RFP 2016-0009 - ADDENDUM 2

COLIGNY REDEVELOPMENT PROJECT

Town of Hilton Head Island, South Carolina

Date Issued: July 29, 2016

SHEET NUMBER
C4.1

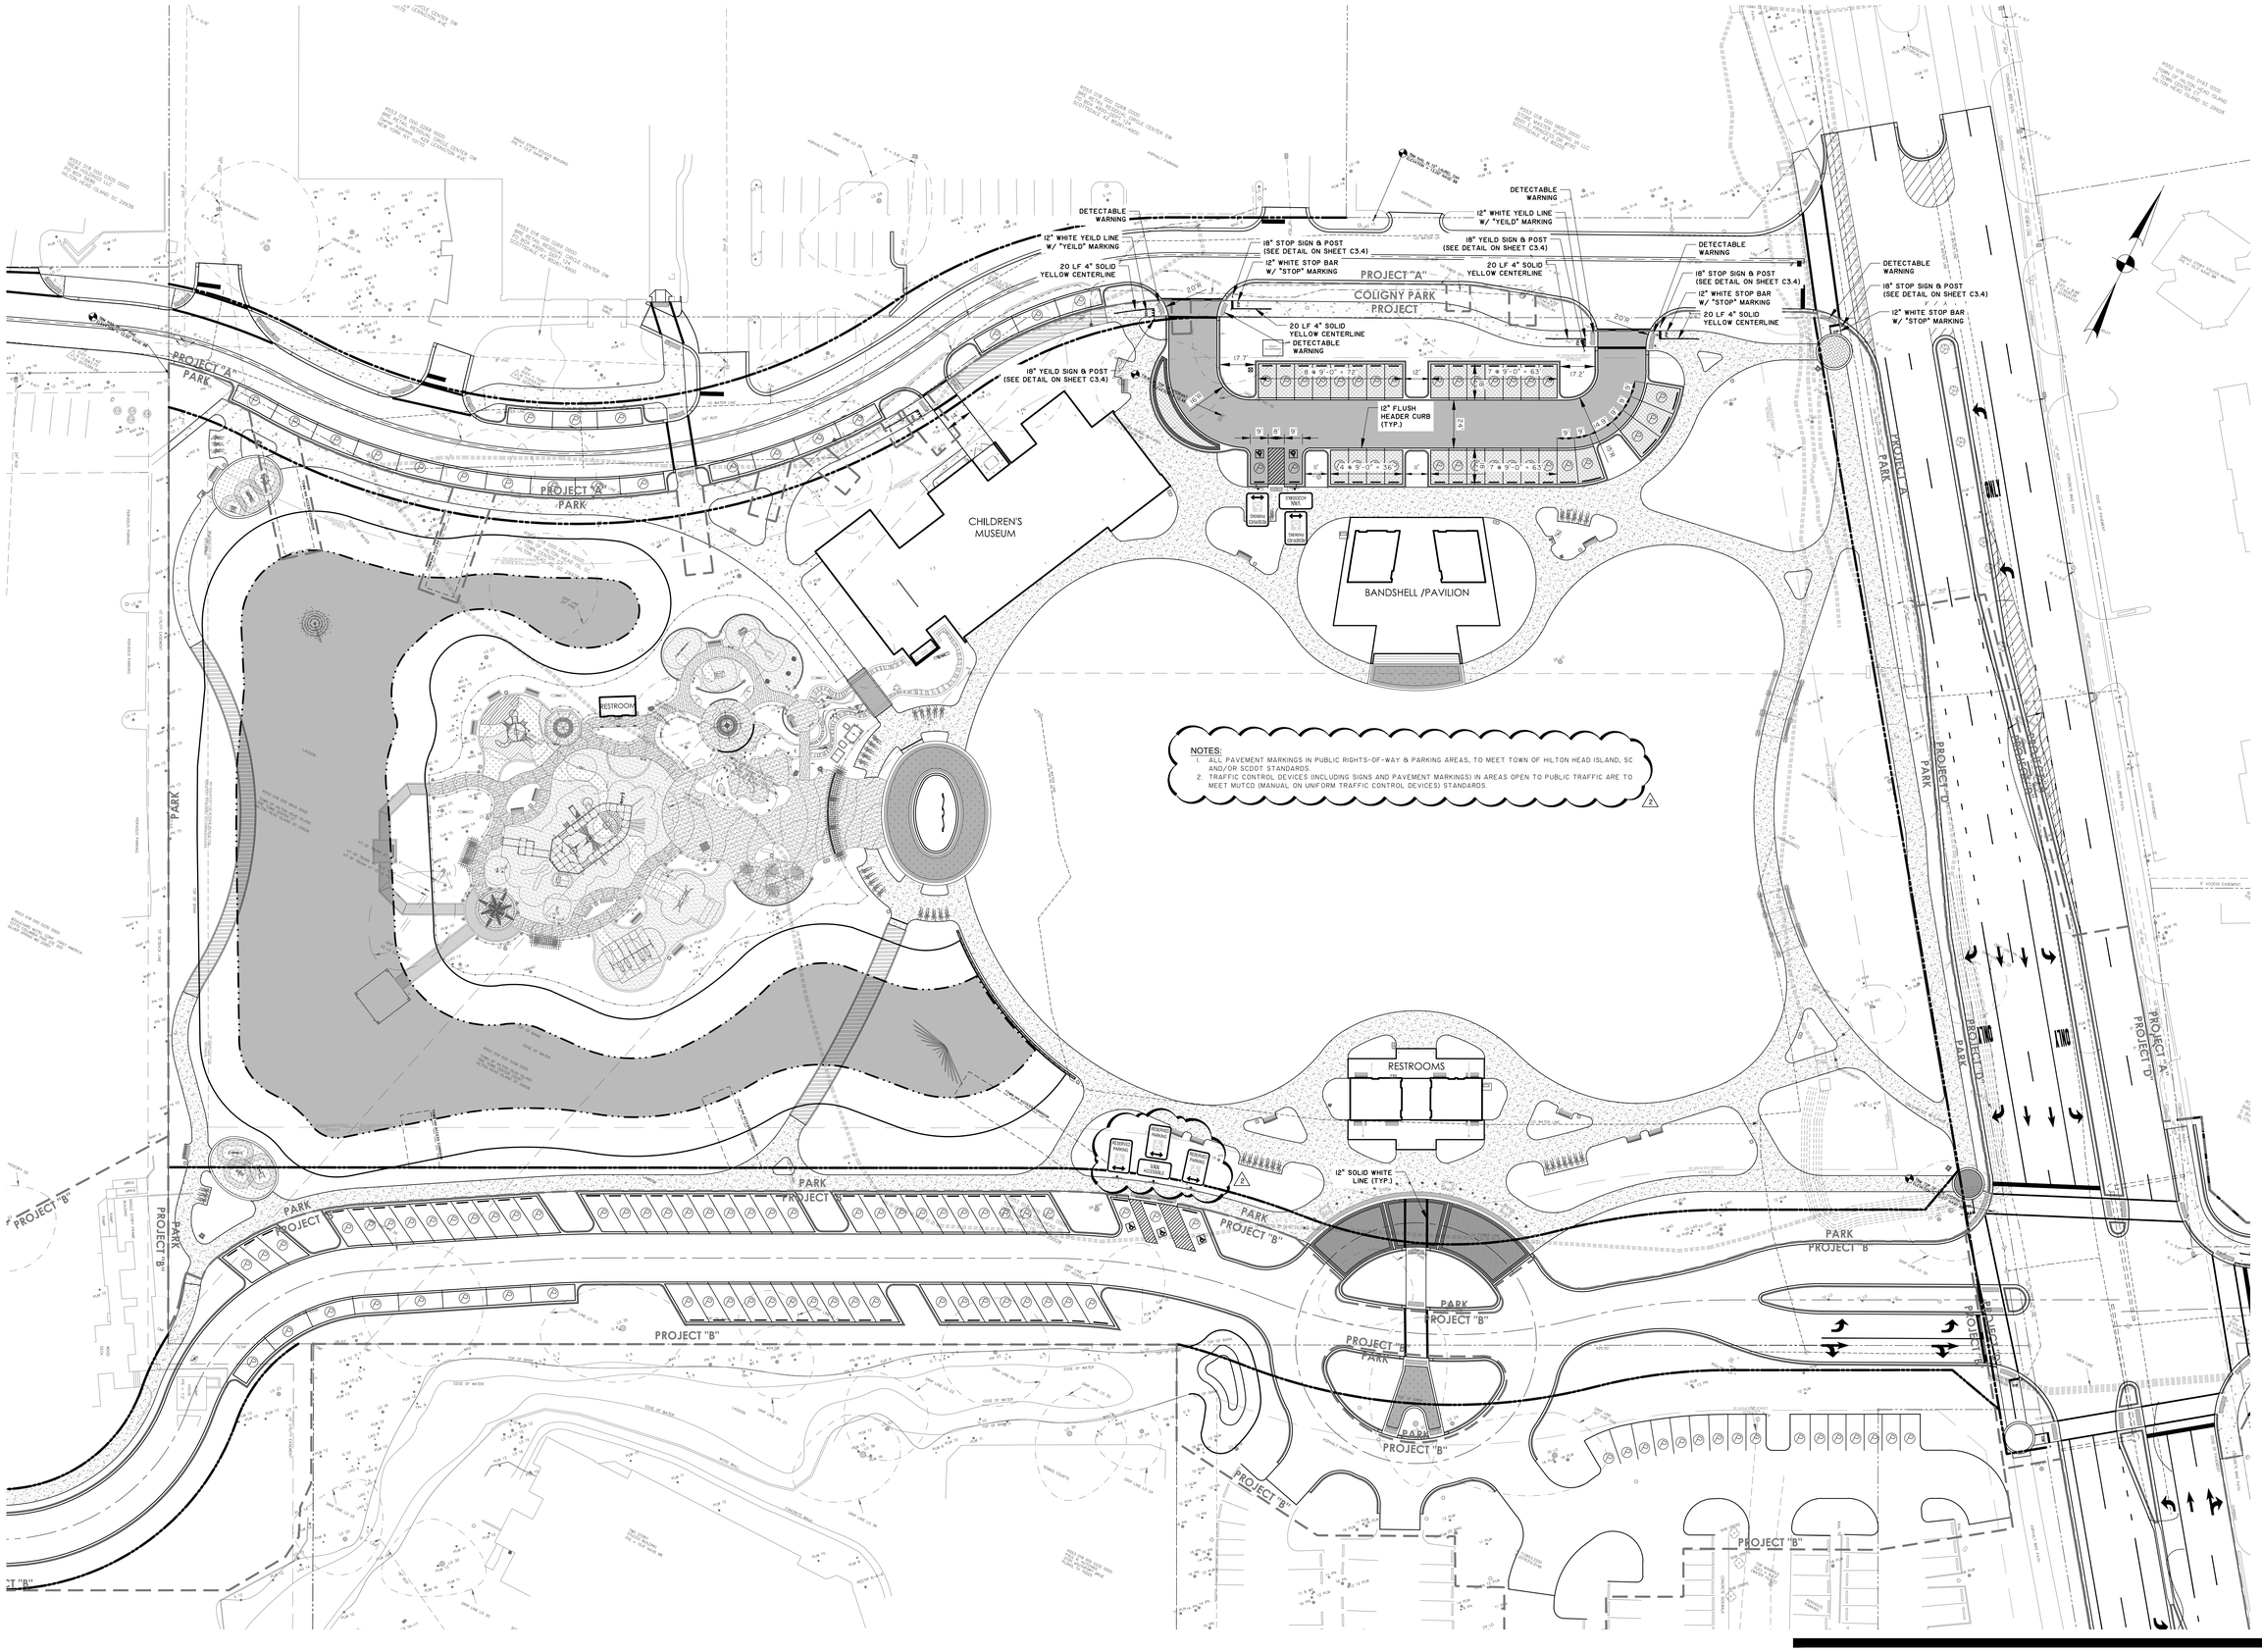
3.5 SHEET C4.1

A. Added Pavement Marking & Signage Notes 1 & 2.
B. Added 3 handicap parking signs to spaces west of restrooms.

10 / P0.501 WATER SERVICE RISER INSTALLATION DETAIL
NOT TO SCALE

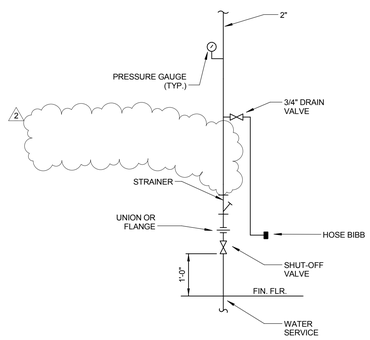
B. Removed backflow preventer in Water Service Riser Installation; Detail 10

SHEET NUMBER
P0.901

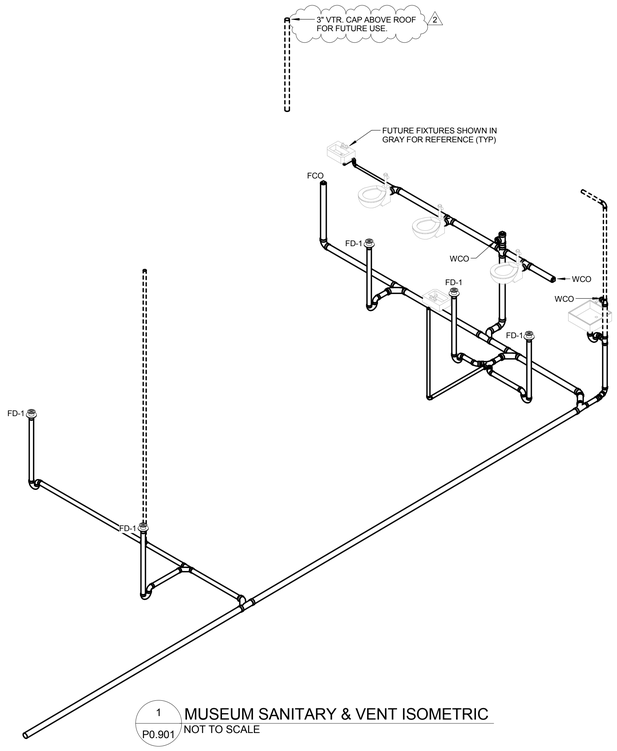
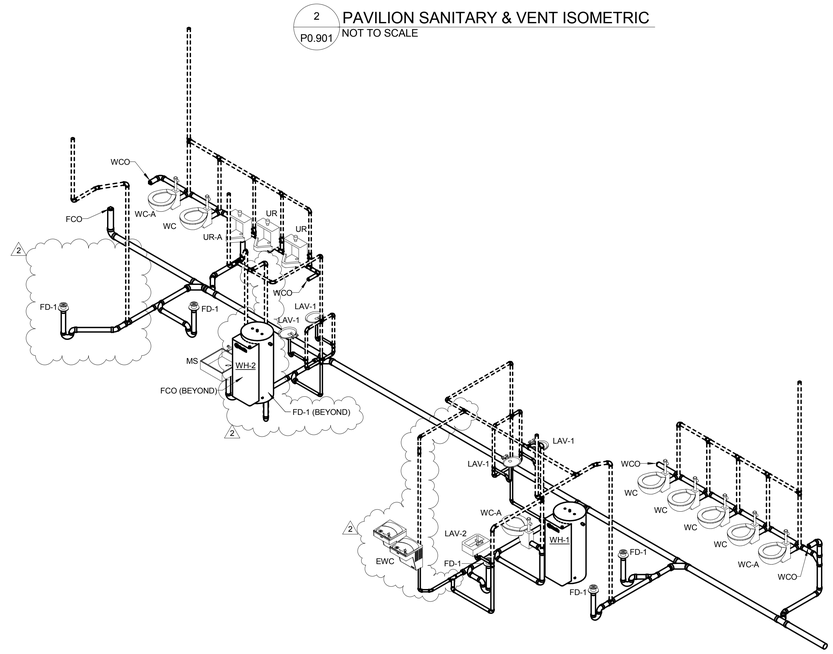
A. Clarified Vent-thru-roof in Museum Sanitary & Vent Isometric.
B. Adjusted floor drain location in Storage room in Restroom Sanitary & Vent Isometric
C. Added floor drain and associated piping changes for relocated water heater WH-2 to Janitor 205 in Restroom Sanitary & Vent Isometric.
D. Added EWC and associated piping changes in Restroom Sanitary & Vent Isometric.

1 / P1.101 MUSEUM DOMESTIC HOT & COLD WATER PLAN
SCALE: 1/4" = 1'-0"

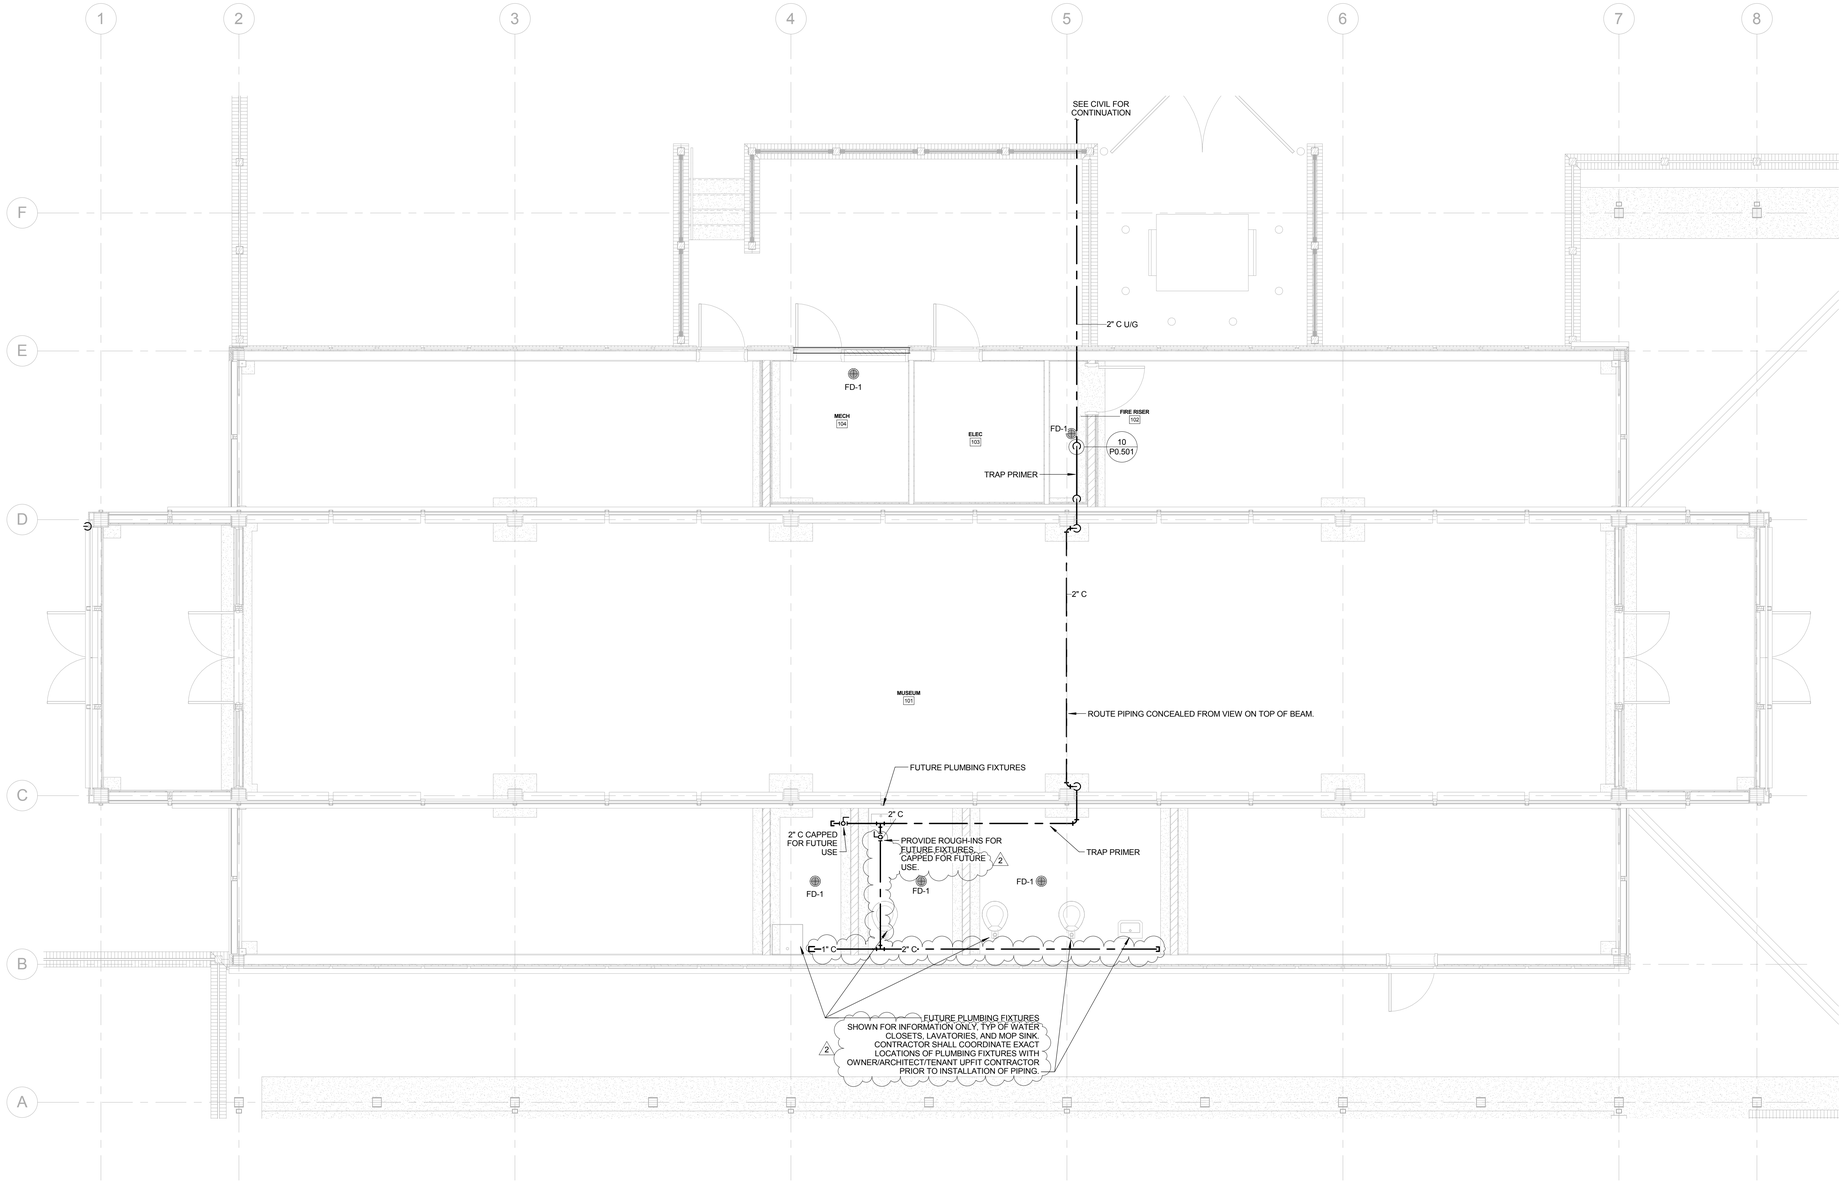
3.8 P1.101 – MUSEUM DOMESTIC HOT & COLD WATER PLAN

A. Added piping to extend rough-in requirements.
B. Clarified requirement for Contractor to coordinate with future fixtures.
C. P1.102 – MUSEUM SANITARY & VENT PLAN
D. Clarified requirement for Contractor to coordinate with future fixtures.

2 P2.101 RESTROOM - DOMESTIC HOT & COLD WATER PLAN
SCALE: 1/4" = 1'-0"

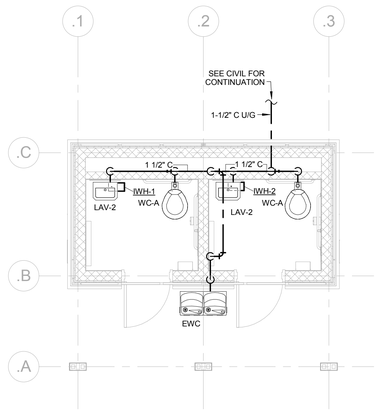
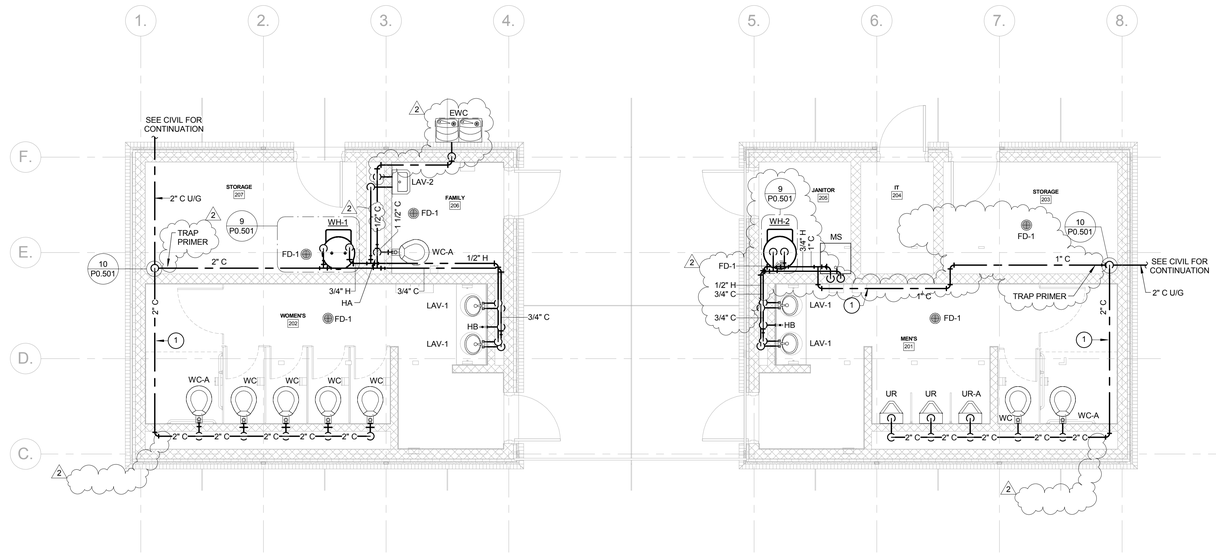
3.9 P2.101 – RESTROOM DOMESTIC WATER PLANS

A. Relocated water heater WH-2 from Storage 203 to Janitor 205, and associated piping changes.
B. Added EWC outside of Family Restroom 206 and associated piping changes.
C. Clarified proposed trap primer locations and piping sizes.

2 P2.102 RESTROOM SANITARY & VENT PLAN
SCALE: 1/4" = 1'-0"

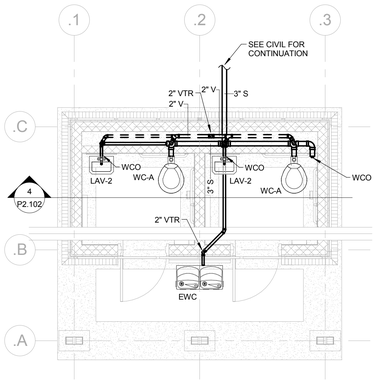
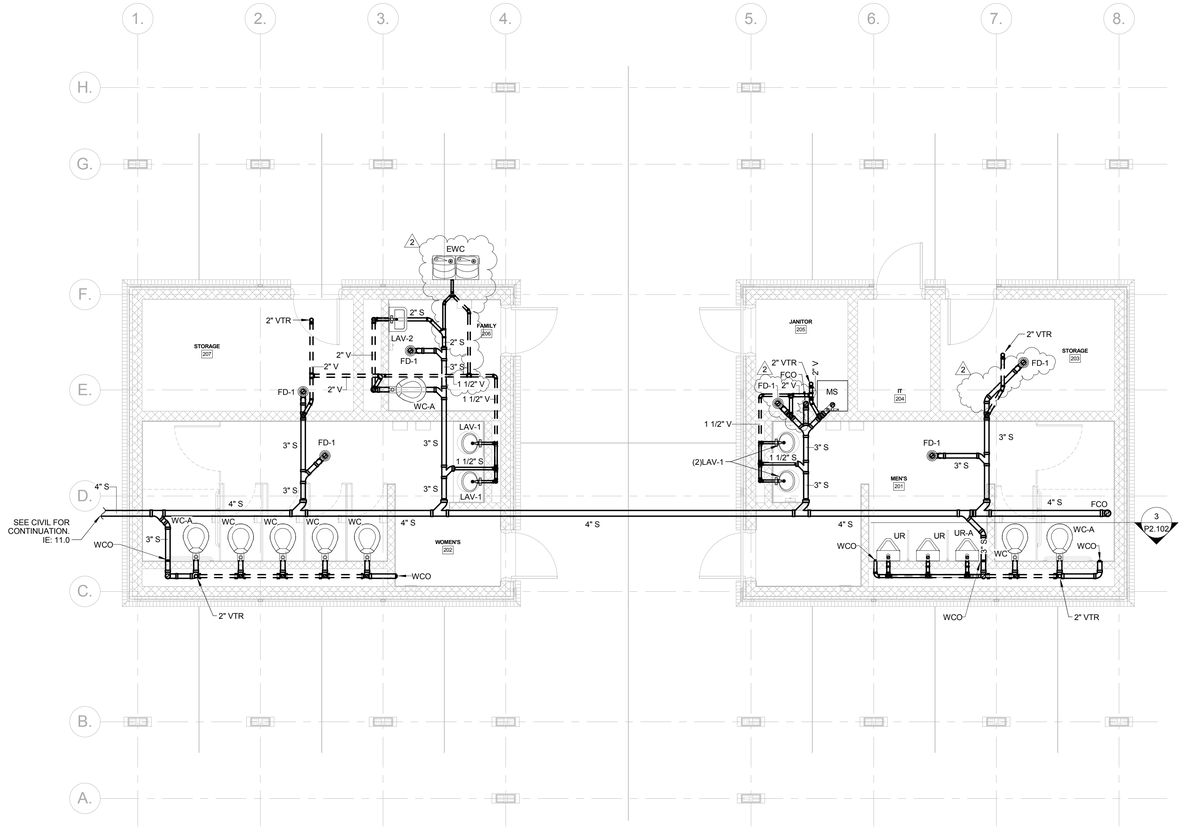
3.10 P2.102 – RESTROOM SANITARY & VENT PLANS

A. Added floor drain and associated piping changes for relocated water heater WH-2 to Janitor 205.
B. Added EWC outside of Family Restroom 206 and associated piping changes.
C. Adjusted floor drain location in Storage 203.

1 / P3.101 PAVILION DOMESTIC HOT & COLD WATER PLAN
SCALE: 1/4" = 1'-0"

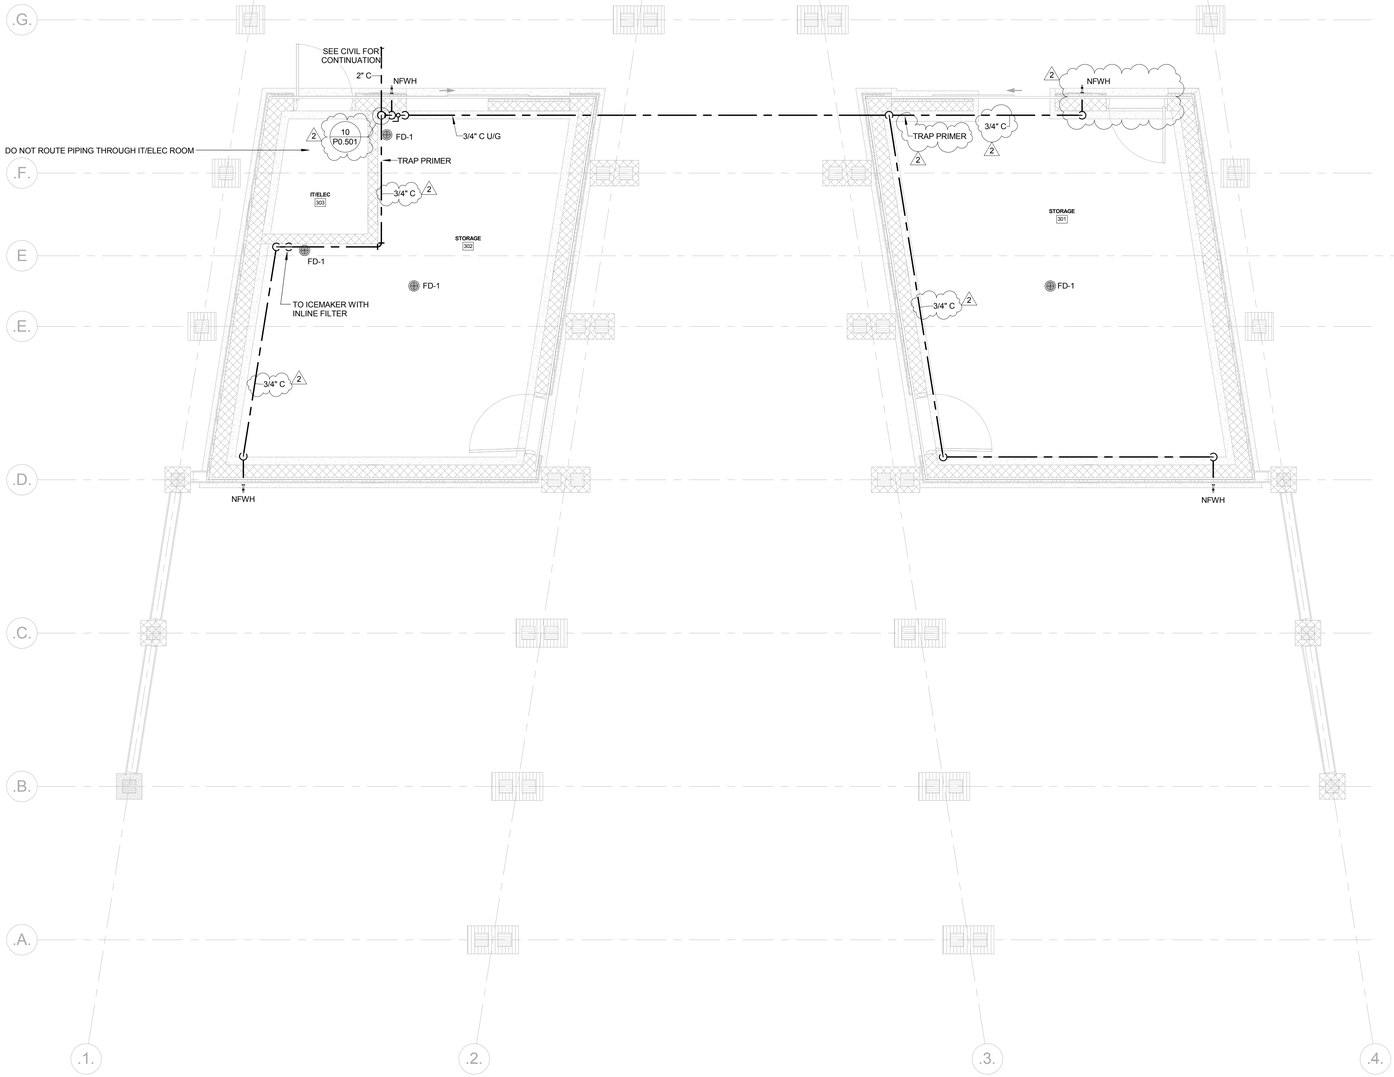
3.11 P3.101 – PAVILION DOMESTIC WATER PLAN

A. Clarified pipe sizes, fixture locations, and detail callouts.
